Substantive response of the Local Highway Authority to a planning consultation received under The Development Management Order.

Planning Application Number: 24/00083/HYB

Application Address: Land At Burbage Fields Farm Bullfurlong Lane Burbage Leicestershire

Hybrid planning application for 422 dwellings, public open space, associated infrastructure and the demolition of 65 and 65a Coventry Road, and Burbage Fields Farm and outline planning application for a residential care home and up to 11no. self-build plots (all matters reserved except for access)

Figure 2: Extent of Personal Injury Collision study area included in Appendix 3 of Rodgers Leask Limited Transport Assessment (TA), Revision P07, dated November 2023.

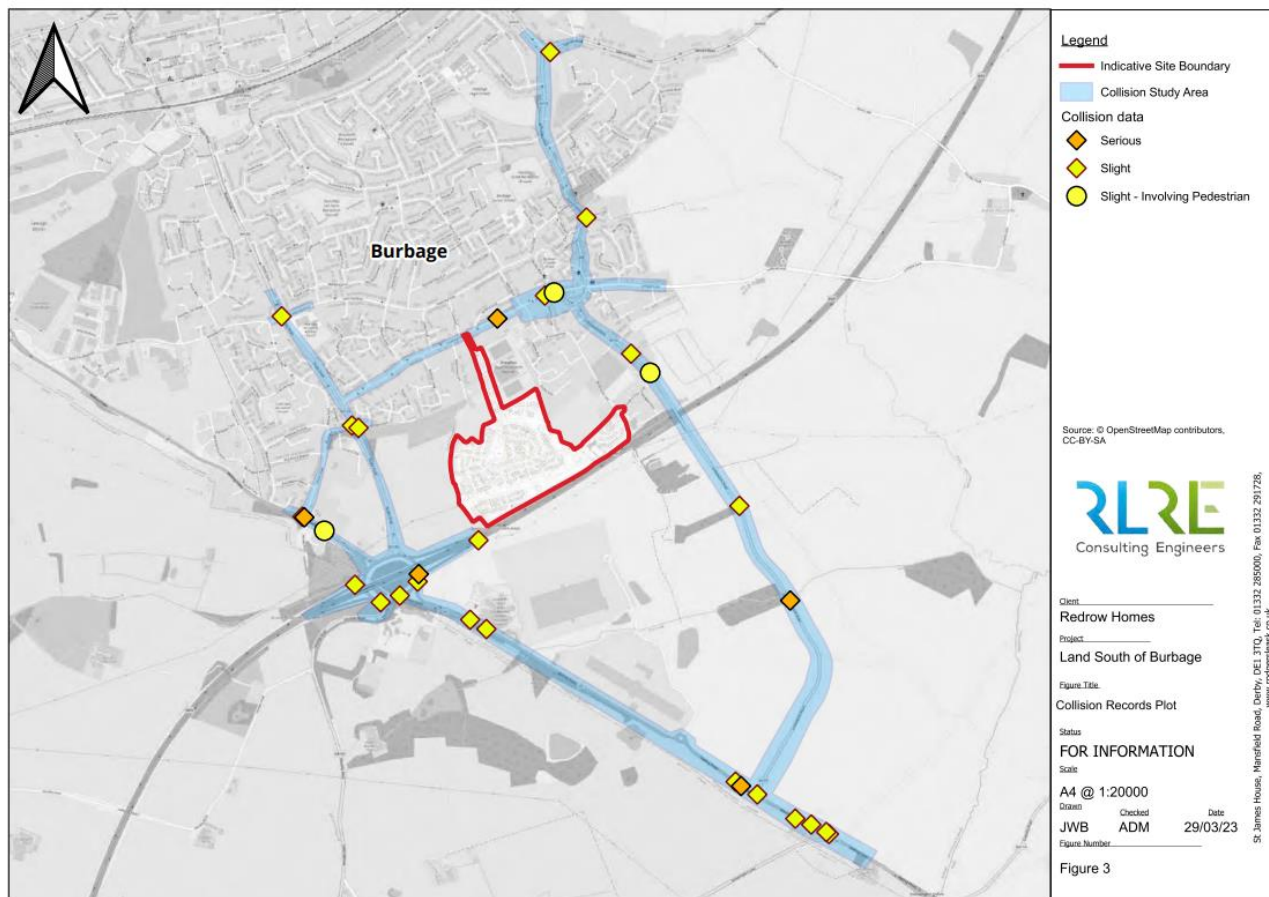
The PIC data from Leicestershire County Council has been considered for the period between 1 January 2018 and January 2022. The applicant has identified 28 PICs on the Leicestershire network in the study area. To understand the current situation with the collision data the applicant should contact LCC for the latest PIC data and submit for review.
